Technical Service Bulletin

SUBJECT:		DRIVER'S SEAT GRADUALLY & UNINTENTIONALLY MOVES DOWN		No: TSB-22-52A-004
				DATE: July 2022
				MODEL: See Below
CIRCULATE TO:	<input type="checkbox"/> GENERAL MANAGER	<input checked="" type="checkbox"/> PARTS MANAGER	<input checked="" type="checkbox"/> TECHNICIAN	
<input checked="" type="checkbox"/> SERVICE ADVISOR	<input checked="" type="checkbox"/> SERVICE MANAGER	<input type="checkbox"/> WARRANTY PROCESSOR	<input checked="" type="checkbox"/> SALES MANAGER

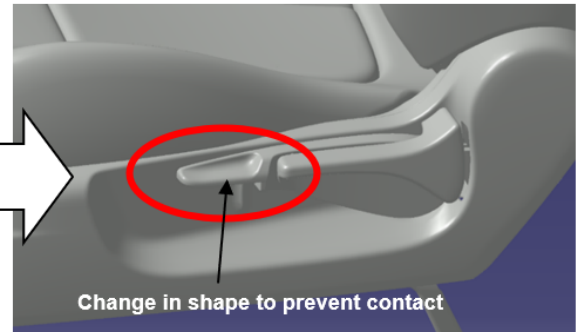
This TSB instructs dealers on how to replace the height adjuster lever with a new part on a customer complaint basis. The shape of the high adjuster lever has been changed to help prevent unintentional adjustment and downward seat movement.

【Current shape】

【New Shape】
